**FINDINGS AND RECOMMENDATION  
OFFICE OF PLANNING AND ZONING  
ANNE ARUNDEL COUNTY, MARYLAND**

**CASE NUMBER:** 2024-0197-V

**REQUEST**

The applicants are requesting a use variance to allow a new single-family detached dwelling in an OS – Open Space District on property located at 1003 Mount Zion Marlboro Road in Lothian.

**PLAN SHEET**  
 GRADING, EROSION AND SEDIMENT CONTROL PLAN

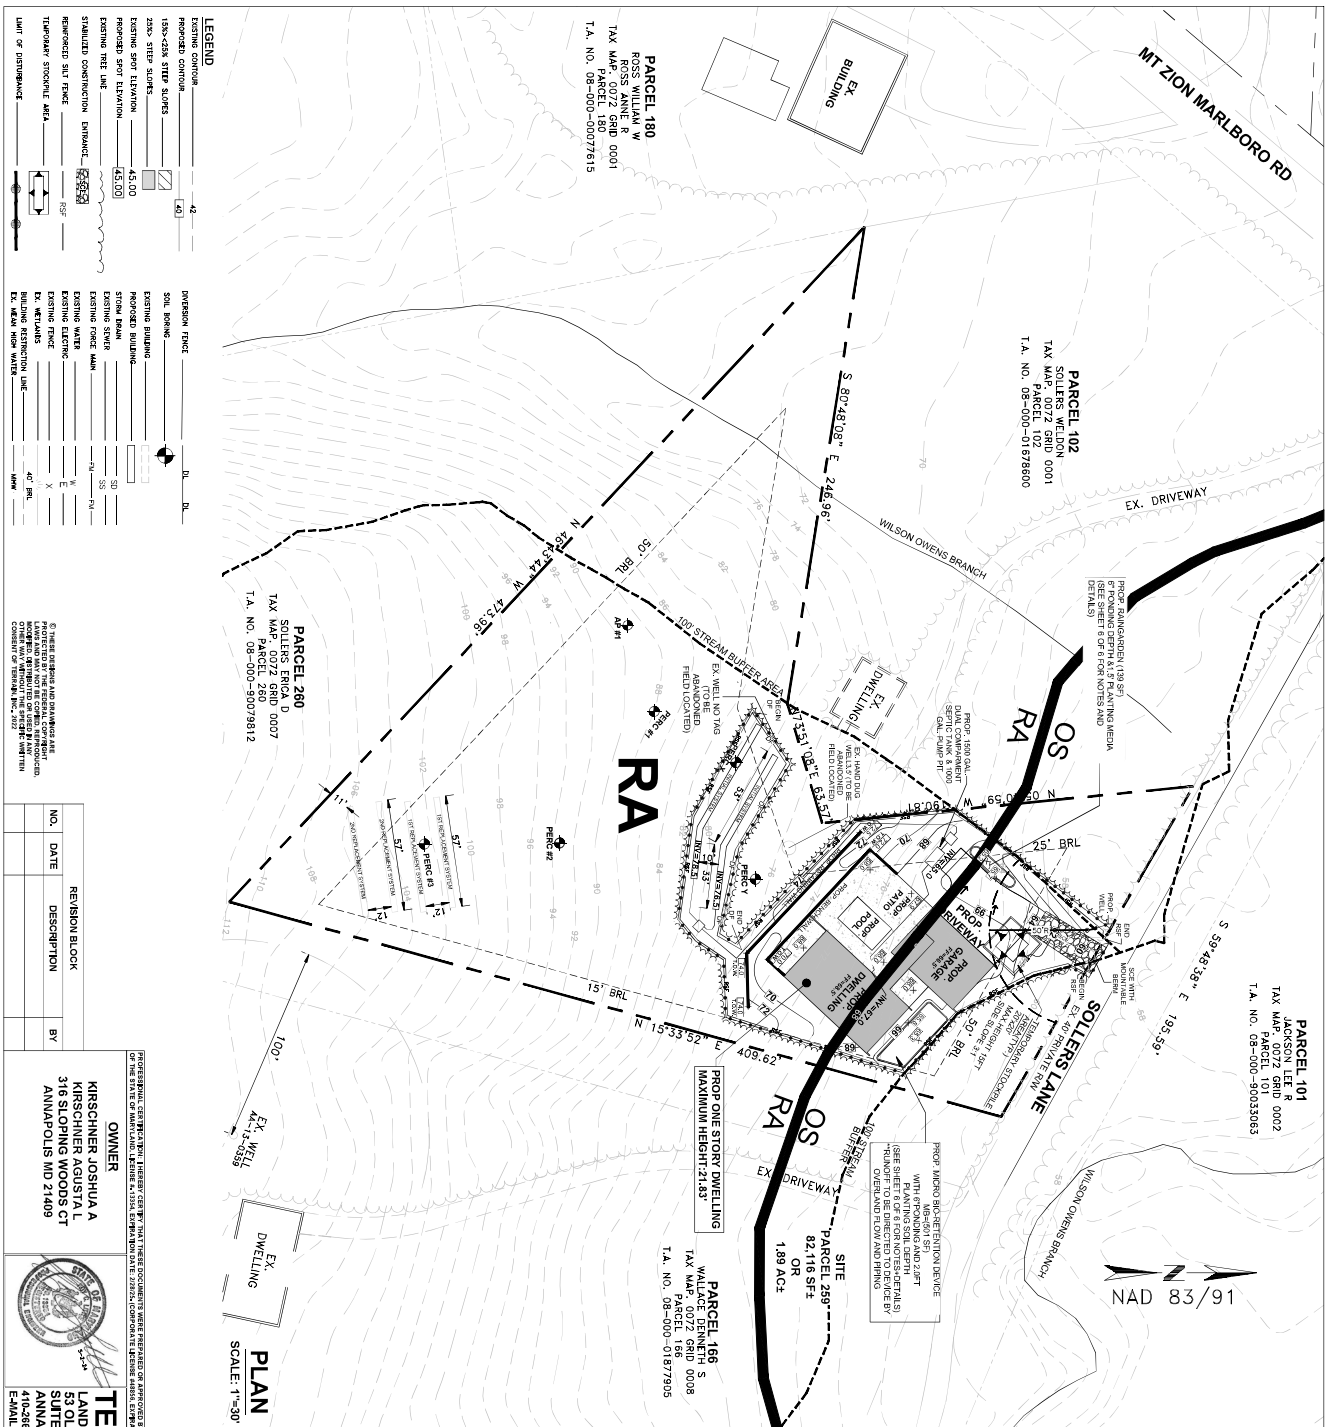
The site plan must clearly label the height and number of stories of the proposed dwelling. The OS label shown on the site plan covers some of the proposed development area and should be relocated for clarity. The applicant should explore ways to minimize the proposal as it does not appear to represent the minimum necessary. The development contains a large garage, patio and pool. It appears that the development could be reconfigured into a smaller area and the pool could be eliminated as pools are generally not considered necessary for the use and enjoyment of a residential lot. The applicant will need to provide adequate justification on how the proposal meets the variance standards contained in 18-16-305.

2. All stormwater conveyance systems shall be designed so that no building or habitable structure, either proposed or existing, is flooded or has water impounded against it during the 100-year storm event.

3. Per 6.1.4 (G) of the County Stormwater Practices and Procedures manual, SWM facilities shall not be located in areas that are off-limits to development, e.g., natural resource areas and their steep slopes and buffers.

4. Ensure the proposed improvement including runoff, seepage, and slope saturation does not adversely impact the integrity of the slope and potential impact of slope failure.

5. A soil boring is required per practice. The suitability, and siting of proposed SWM practices should be reviewed. Soil boring information including verification of the suitability of in-situ soils for infiltration shall be submitted.

6. The soil boring results, including the seasonal high groundwater elevation, need to be added to the plan. The calculations will not be reviewed until the siting and suitability are first confirmed to be adequate.

**Response: The dwelling labels have been added to the plan. This will be a one-story building with a ridge height of 21.83'. The plan has been revised for clarity. It is our belief that the house design and layout is minimum necessary as it is a modest sized house that is less than half of the maximum lot coverage and under the allowable clearing limitations.**

**Response: The SWM facilities are downstream from the proposed structure. The 100-year storm will safely be conveyed away from the proposed structure to the existing stream located north of the property.**

**Response: The proposed SWM facilities are located outside of the environmentally protected areas.**

**Response The proposed improvements will have a safe conveyance for the discharge. There will be no impact to the integrity of the slope.**

**Response: A soil boring has been included with the Grading Permit Submittal set.**

**Response: The soil boring shown on the Grading Permit Submittal verifies that high ground water will not impact the adequacy of the SWM facility.**
